Summary notes for the June 24, 2020 – Rumford Falls Project MDEP Site Visit

Purpose: Visual evaluation of the bypassed reach downstream of the Middle Dam and the lower powerhouse tailrace area to determine sampling locations for three components of the proposed water quality study (temperature and dissolved oxygen monitoring, benthic macroinvertebrates, and outlet stream aquatic habitat study).

Figure 1. Preferred deployment location downstream of Middle Dam for the temperature/DO logger and macroinvertebrate samplers.

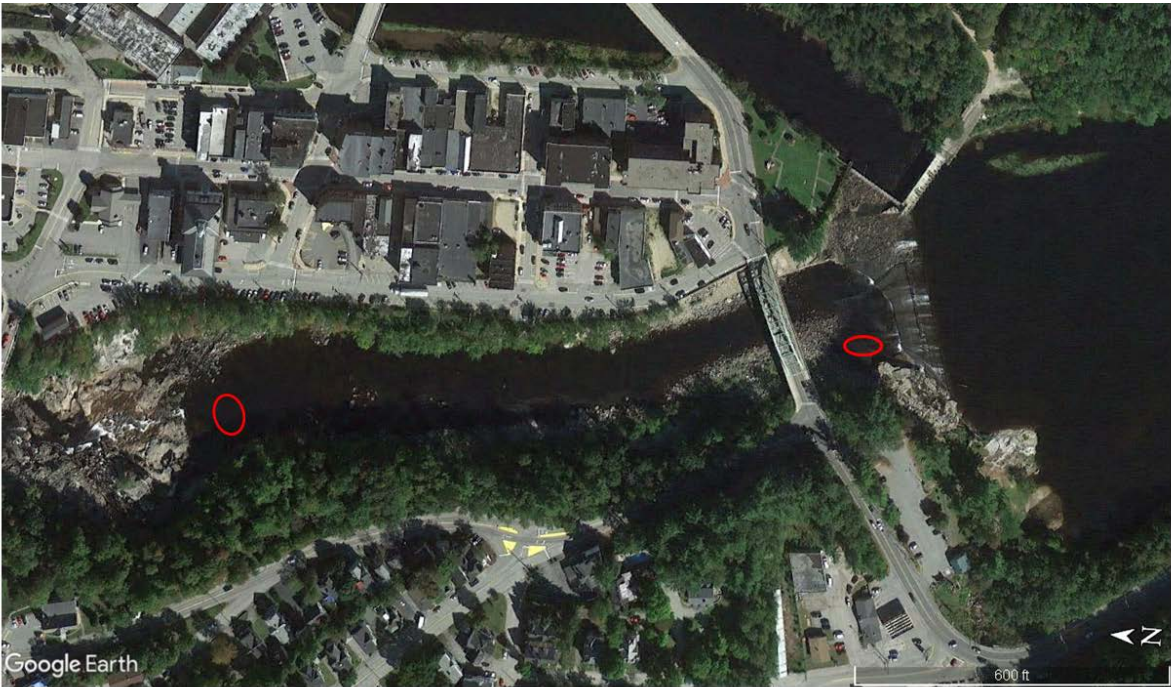
- Logger downstream of Middle Dam – preferred location
 - See Figures 1 and 2.
 - Logger should be placed in location downstream of bypass pipes and dam spouts so that unit remains submerged for duration of monitoring period.

- Normandeau to collect photos of this area during June 29 trophic sampling to provide to MDEP for confirmation that appropriate wetted habitat is available at this location when no spill flows are present over Middle Dam.

- Normandeau to select specific location with appropriate substrate and adequate water depth for deployment period in the vicinity of the temperature/DO logger (Figures 1 and 2).

Figure 3. Alternate deployment location downstream of Middle Dam for the temperature/DO logger and macroinvertebrate samplers.

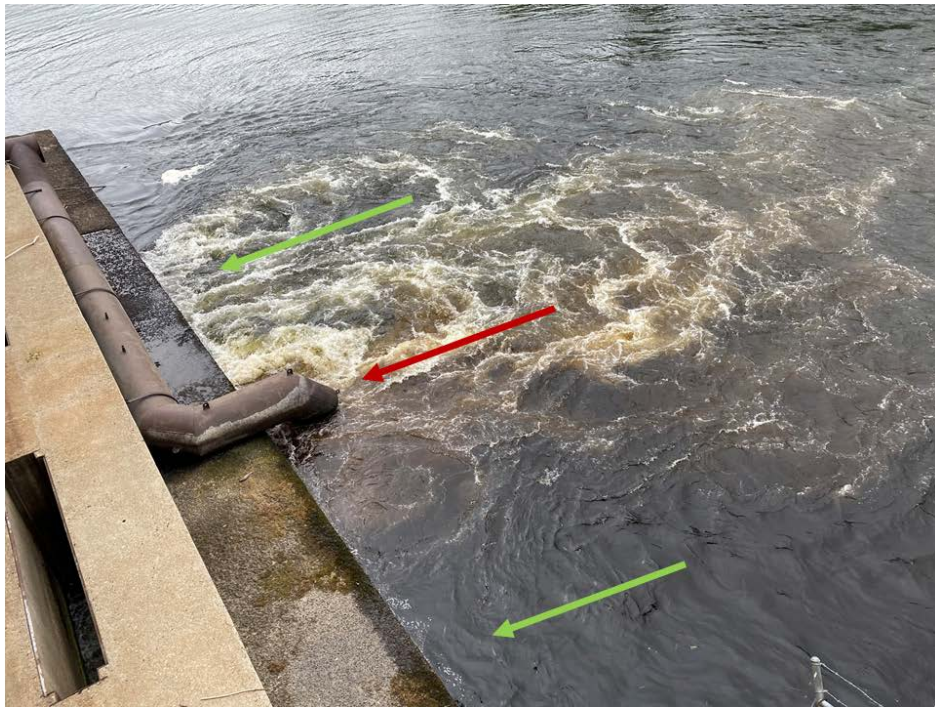
- Logger downstream of Middle Dam – secondary location
 - See Figures 2 and 3.
 - In the event it is determined that sufficient wetted area and water depths at the preferred location are not available then logger will be installed in pool habitat located just upstream of the bedrock cascade portion of bypassed reach.

- In the event it is determined that sufficient wetted area and water depths at the preferred location are not available then invertebrate samplers will be installed in pool habitat located just upstream of the bedrock cascade portion of bypassed reach.

Figure 5. Power canal deployment location for the temperature/DO logger to be considered representative of conditions downstream of the confluence of the bypassed reach and lower powerhouse discharge.

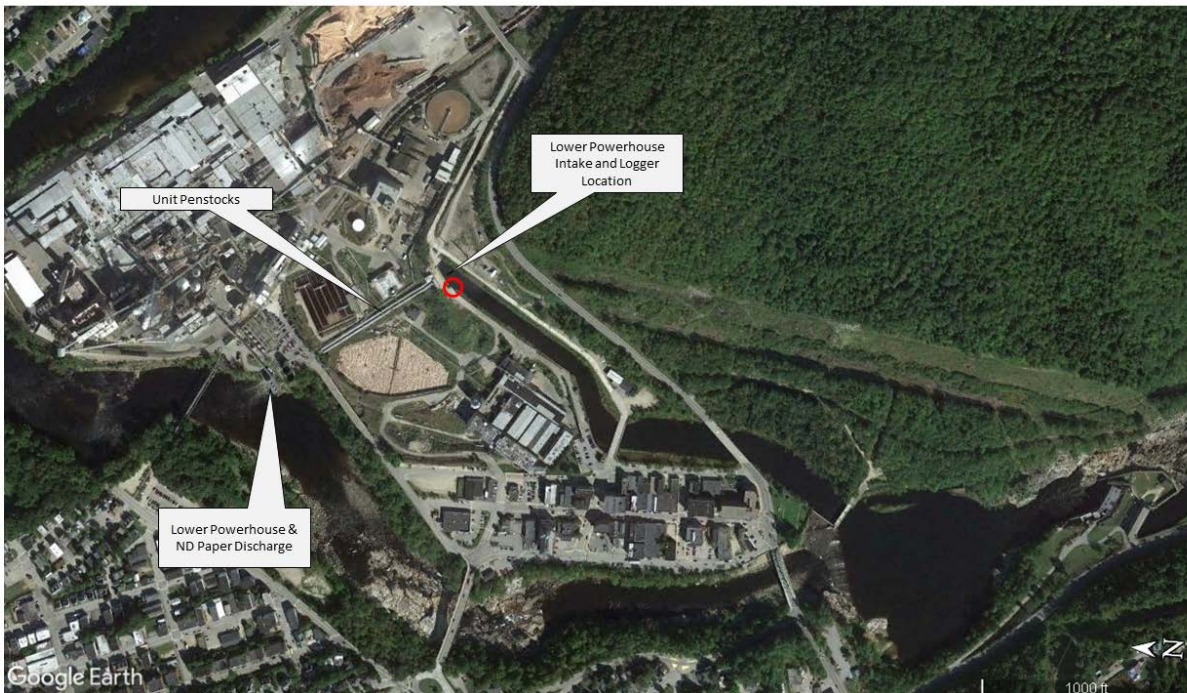
- Maine DEP indicated that the placement of a temperature/DO logger at the downstream end of the power canal (adjacent to the lower powerhouse intake) would be representative of water quality following discharge out of the lower powerhouse (Figures 5 and 6).
